# PIC32MZ EF FAMILY

## PIC32MZ Embedded Connectivity with Floating Point Unit (EF) Family Silicon Errata and Data Sheet Clarification

The PIC32MZ Embedded Connectivity with Floating Point Unit (EF) family of devices that you have received conform functionally to the current Device Data Sheet (DS60001320D), except for the anomalies described in this document.

**FIGURE 1: POSC CRYSTAL CIRCUIT**

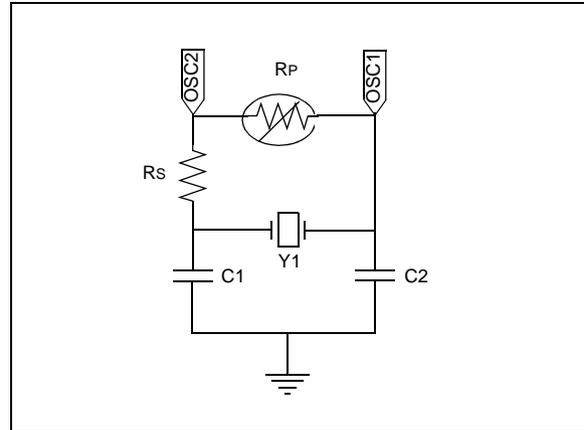
**Revision A3 Silicon:** The Posc has been tested in a normal power-up sequence and supports specific crystal operation.

The Primary Oscillator (Posc) has been characterized to operate at 8 MHz, 12 MHz, and 24 MHz when the circuit in [Figure 1](#) is implemented, and the operating conditions listed in [Table 3](#) are met.

Crystal Frequency (see Note 1)	Series Resistor (Rs)	Posc Gain Setting POSCGAIN<1:0> (DEVCFG0<20:19>)	Posc Boost Setting POSCBOOST (DEVCFG0<21>)
8 MHz	2 kΩ	'0b00 (GAIN_0)	'0b1 (ON)
12 MHz	1 kΩ	'0b00 (GAIN_0)	'0b1 (ON)
24 MHz	0 kΩ	'0b00 (GAIN_0)	'0b1 (ON)

- Note 1:** Using any other crystal frequency will require special component selection and characterization.  
**Note 2:** A parallel resistor (Rp) should not be used to increase the gain of the POSC.
